~~Eastern Fabricator~~
DUNDALK ORNAMENTAL
IRON WORKS

2-LINE 1 1/2" PIPE RAIL

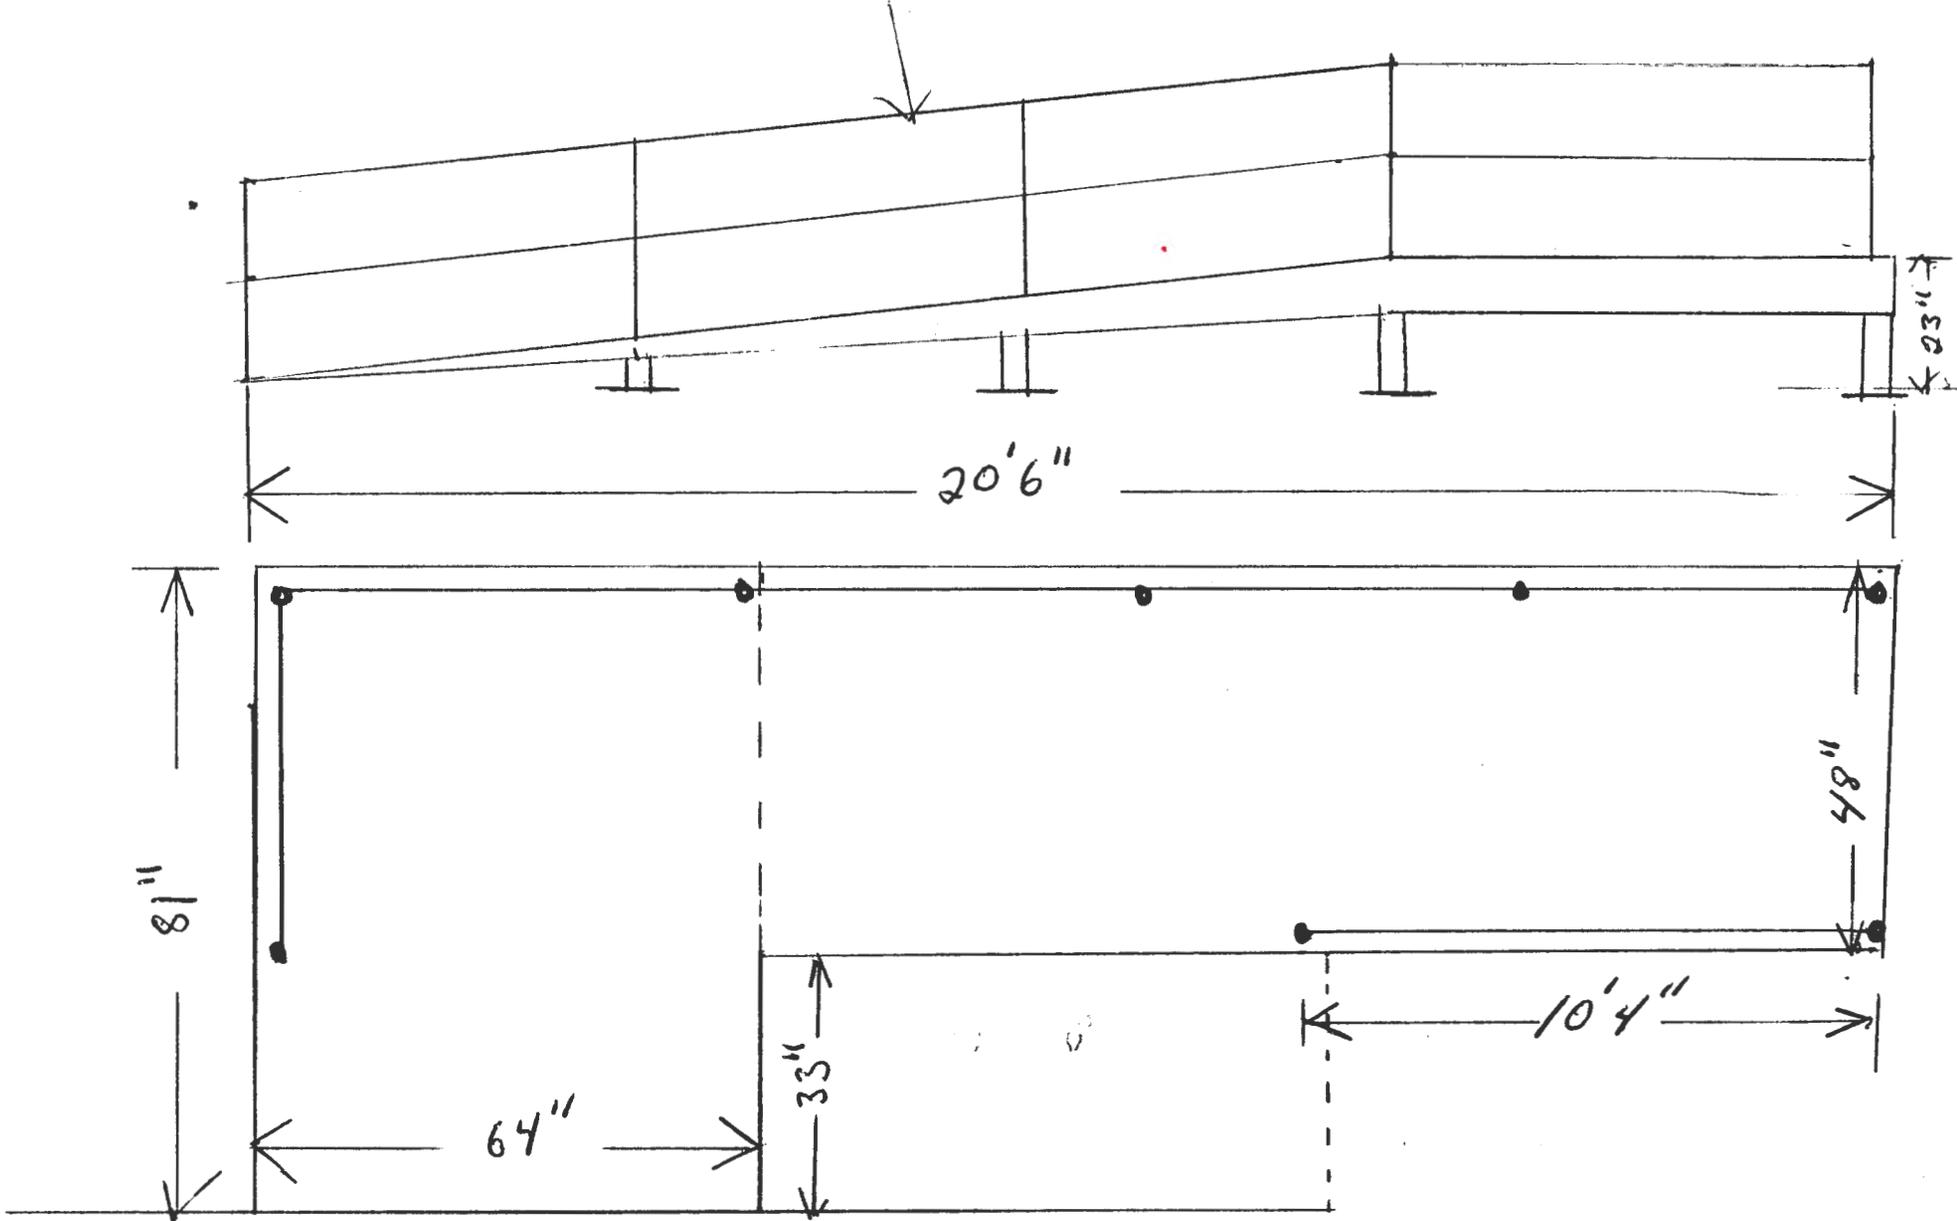
RAILING will NOT be attached to building.
GATE in door must be cut down to clear walkway.
TUBING OR ANGLE CAN be anchored to SIDEWALK if NEEDED.
